ADMINISTRATION REPORT **REZONING, PLAN AMENDMENT** GARNEAU

11023, 11027, 11031, 11033, 11037, 11039, 11041, 11043, and 11045 86 Avenue NW

To allow for a short mid-rise residential building.

Recommendation: That Bylaw 19462 to amend the Garneau Area Redevelopment Plan and Charter Bylaw 19463 to amend the Zoning Bylaw from the (RF6) Medium Density Multiple Family Zone to a (DC2) Site Specific Development Control Provision be **APPROVED**.

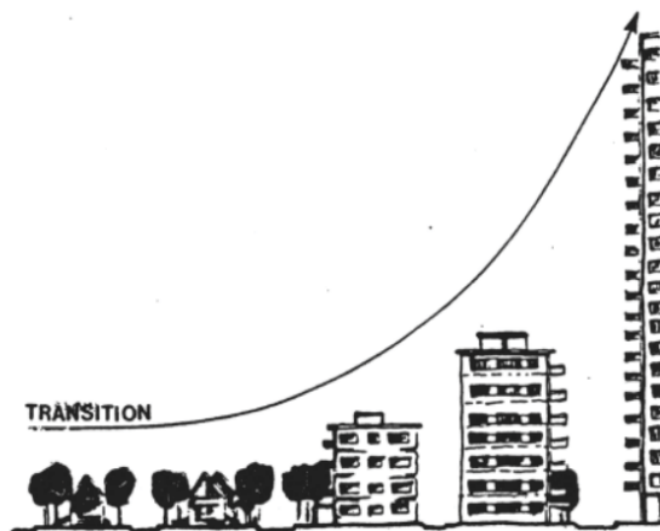
As can be seen when looking at the comparison of the previous and proposed elevations (Appendix 1), these regulations, when enacted, do create the perception of additional articulation and variation of the long facade. However, they are not actual “built form changes” that would more effectively address the issue of the long facade, such as having varying setbacks and stepbacks or vertical recessions in addition to the projections.

It is Administration’s opinion that this part of the motion has been partially satisfied.

GRAPHIC FROM THE GARNEAU ARP SHOWING THE DESIRED TRANSITION IN BUILDING HEIGHTS

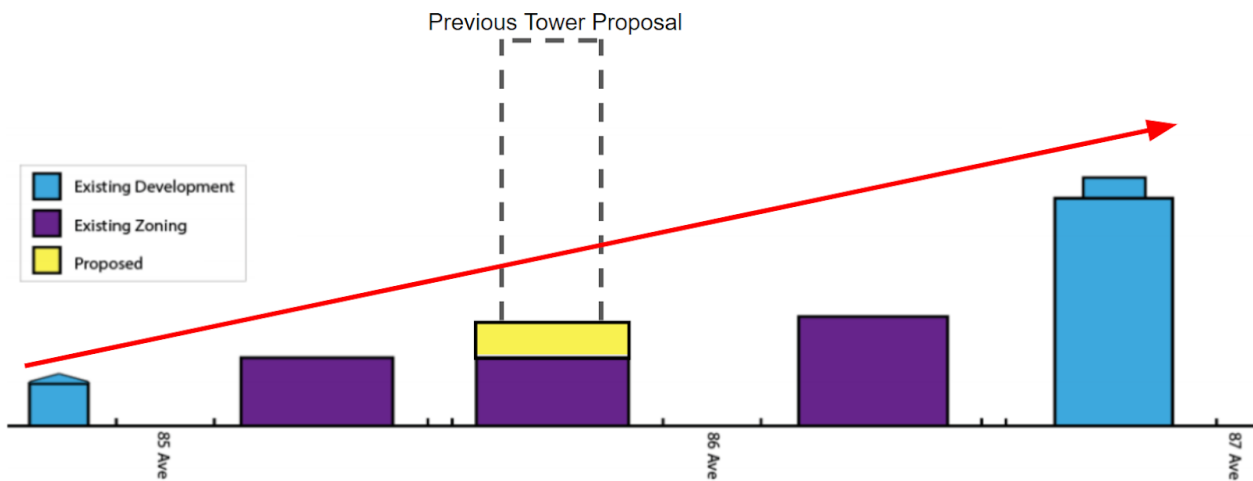
The previous tower proposal would have been a significant intrusion into this transition, but the revised mid-rise building, while adding approximately 2 storeys to the height allowed by the current RF6 Zone, still fits well with this transition as shown below.

The proposed amendment to Policy 1.6a effectively shifts the border between 4 and 6 storeys from being 86 Avenue NW to being the lane south of 86 Avenue NW. This shift is not considered significant and still allows for a sensitive transition to the low scale, heritage focused DC1 Provision to the south.

Appendix 1 – Site Plan – Revised for Council Motion

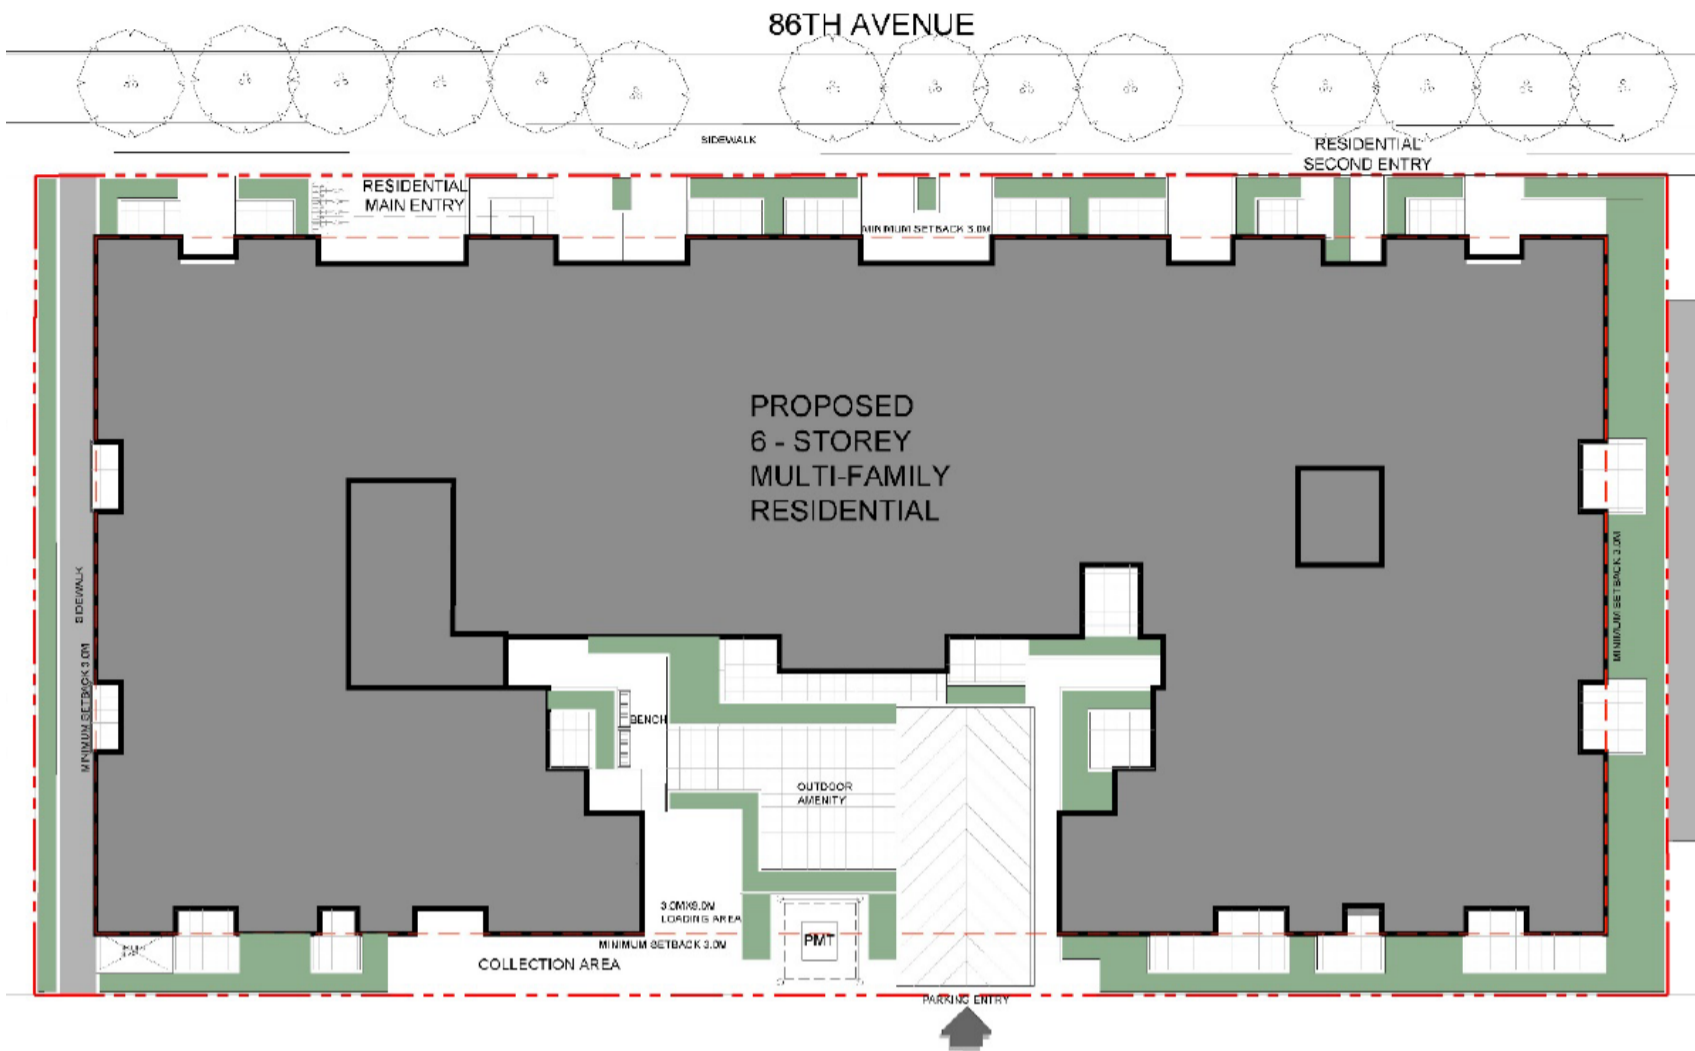
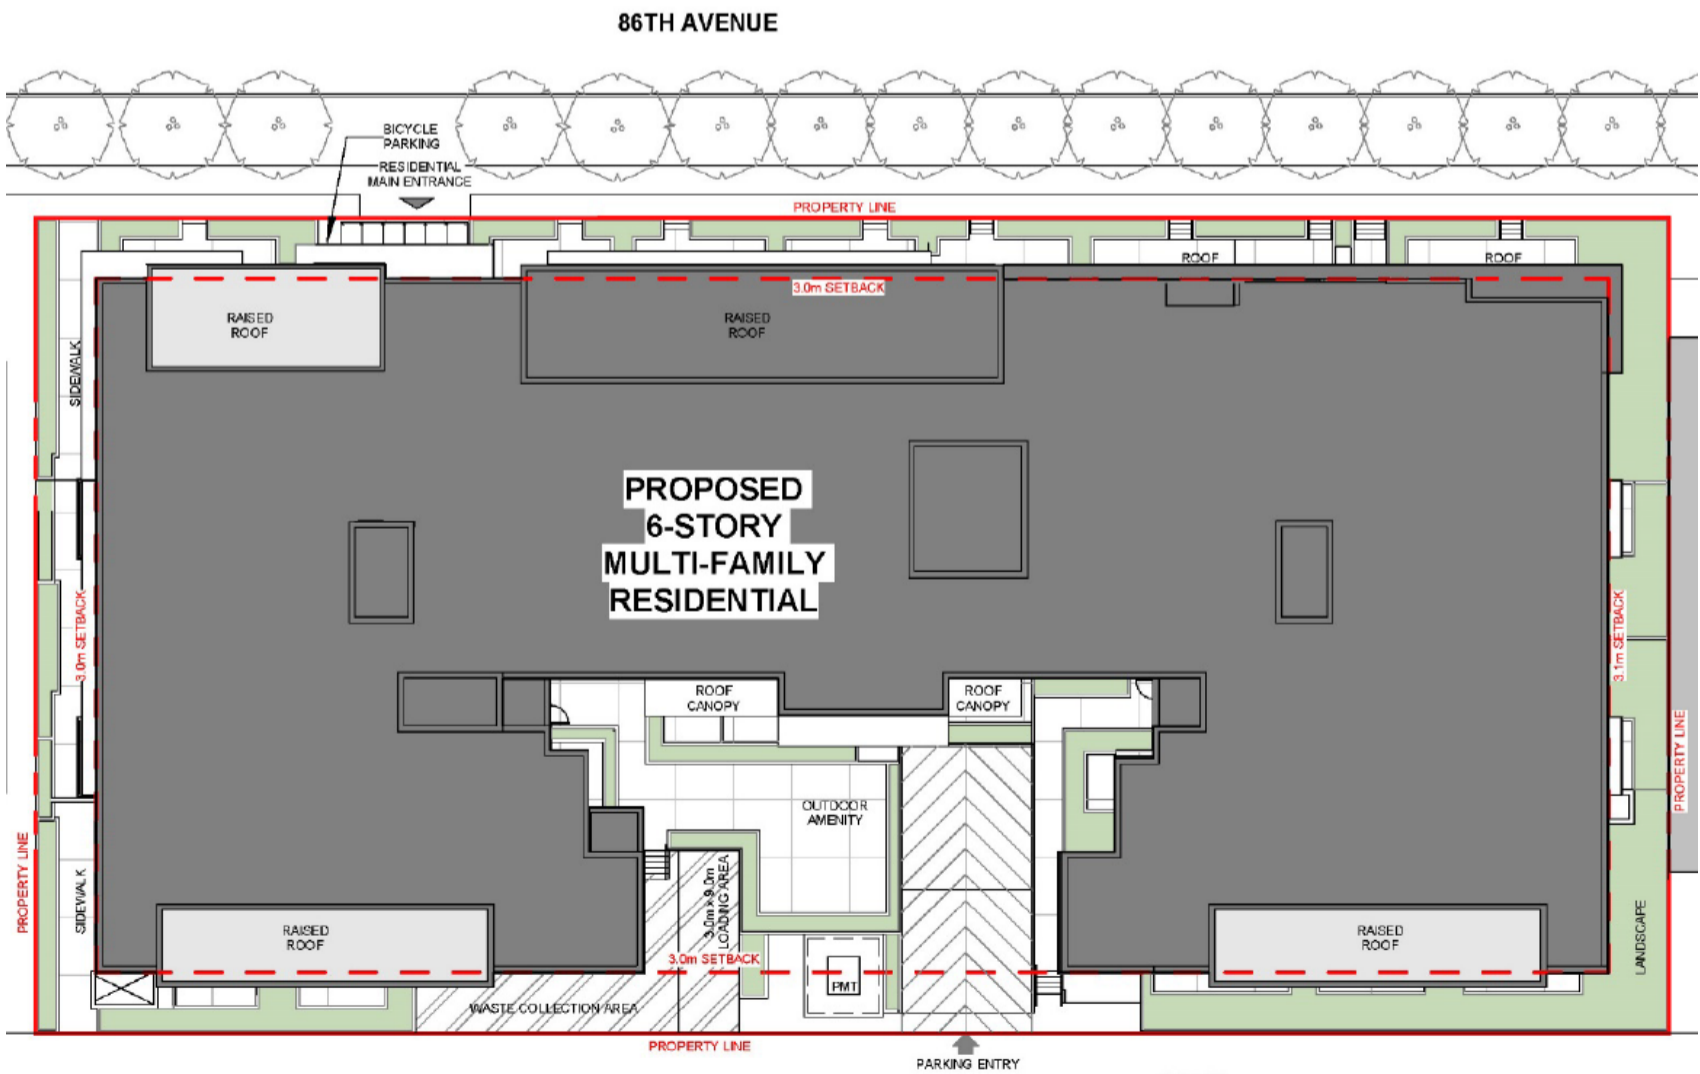
DC2 5.6 - "The building shall have a minimum Setback of 3.9 m from the north Lot line at a maximum Height of 7.6 m for a distance of 6.7 m from the east Lot line."

As the setbacks from the property lines at ground level from the north and east were already proposed at 3.0 m, this is effectively an additional 0.9 metre setback for the easterly 3.7 m of the north facade above the second storey. Administration believes this minor notch in the northeast corner of a building that is 75 metres wide cannot reasonably be said to have any tangible impact on the look or massing of the building. An excerpt from the Site Plan attached to the proposed DC2 Provision showing this minor setback is below.

While this variation may be seen to make the building slightly more aesthetically pleasing, it does not achieve the same outcome of an actual stepback with regards to decreasing the sense of massing and it does not result in "built form changes", as was directed by the motion.

It is Administration's opinion that this part of the motion has not been adequately satisfied.

Appendix 2 – Landscape Plan – Revised for Council Motion

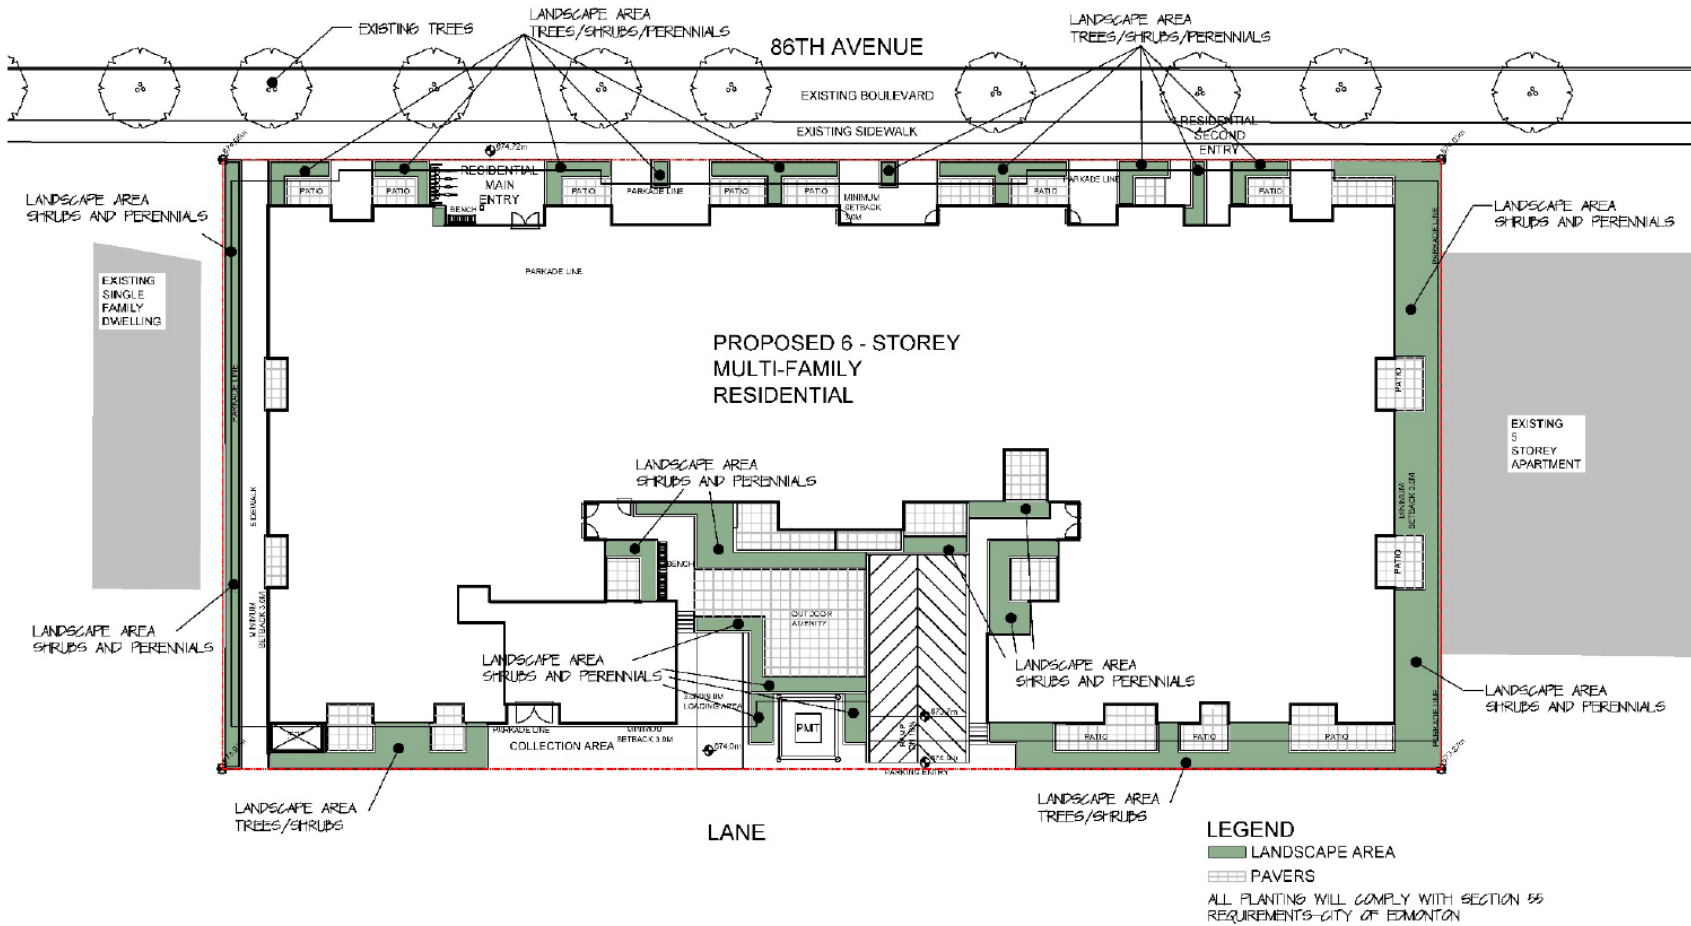
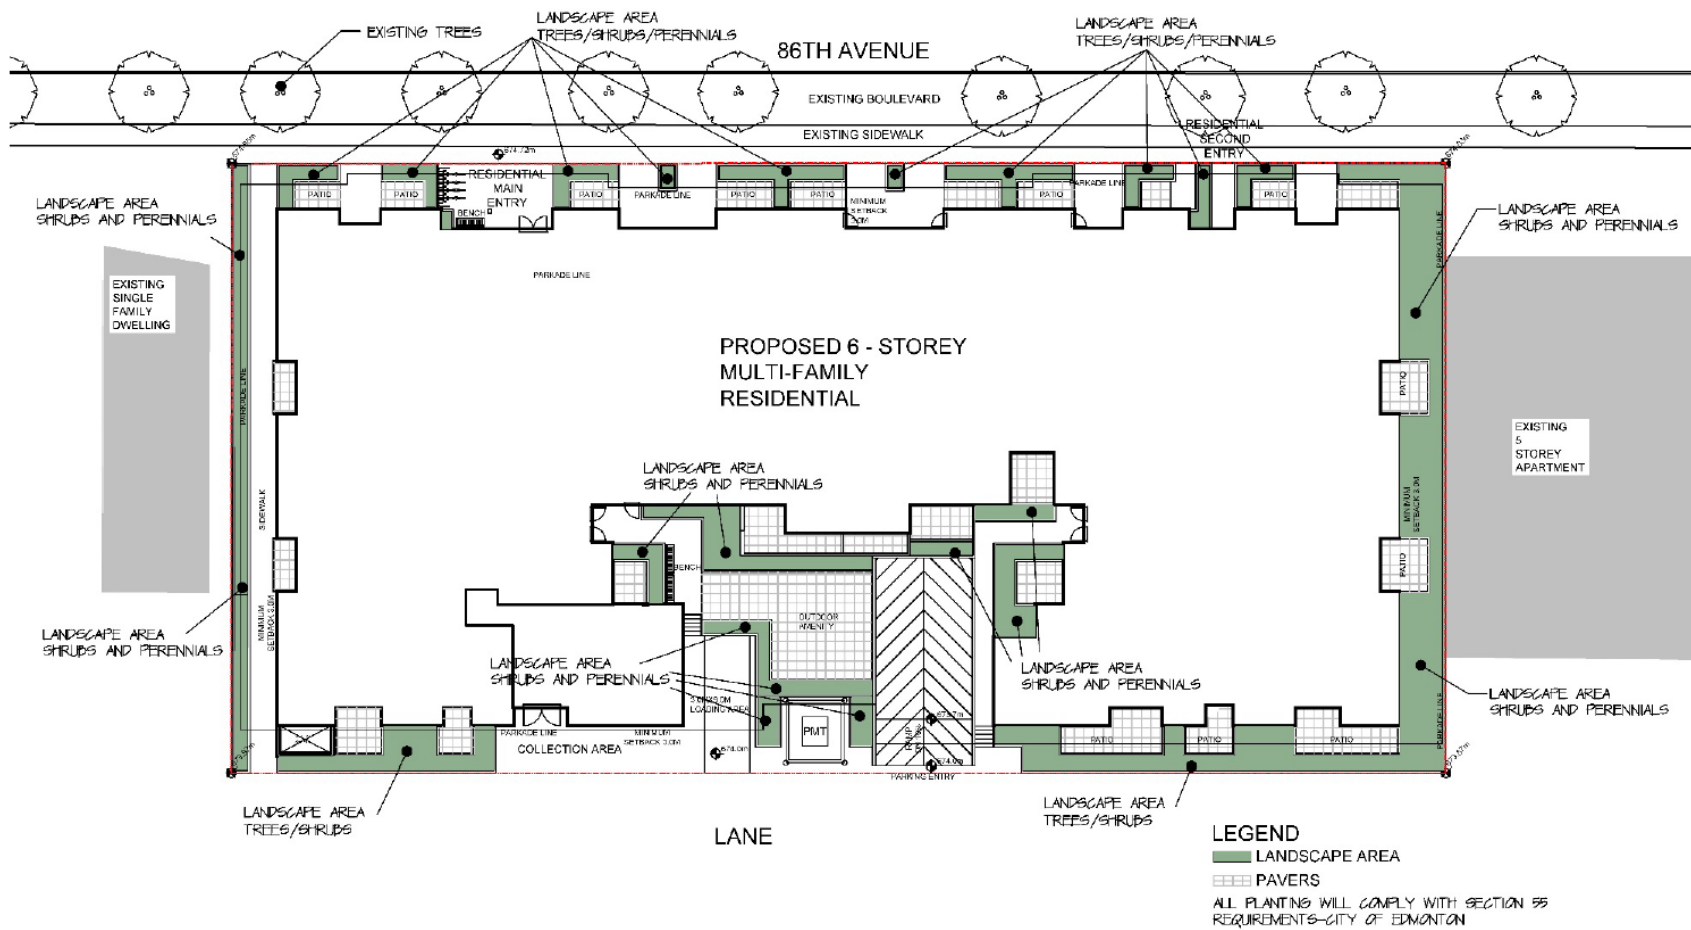
DC2 5.11 - *"Balconies and glazing along the south, east and west Facades of the principal building shall provide adequate screening and be located to maximize privacy and minimize overlook to the adjacent residential properties to the south, east and west. This may include, but not be limited to privacy screens, louvers, frosted glass and/or glass block."*

While it is difficult to show these features in the building elevations appended to the proposed DC2 Provision, this regulation will allow the Development Officer to ensure potential overlook conditions are properly addressed at the Development Permit stage. This regulation is more directive and specific than similar regulations found in standard zones, like the comparable (RA8) Medium Rise Apartment Zone.

It is Administration's opinion that this part of the motion has been adequately satisfied.
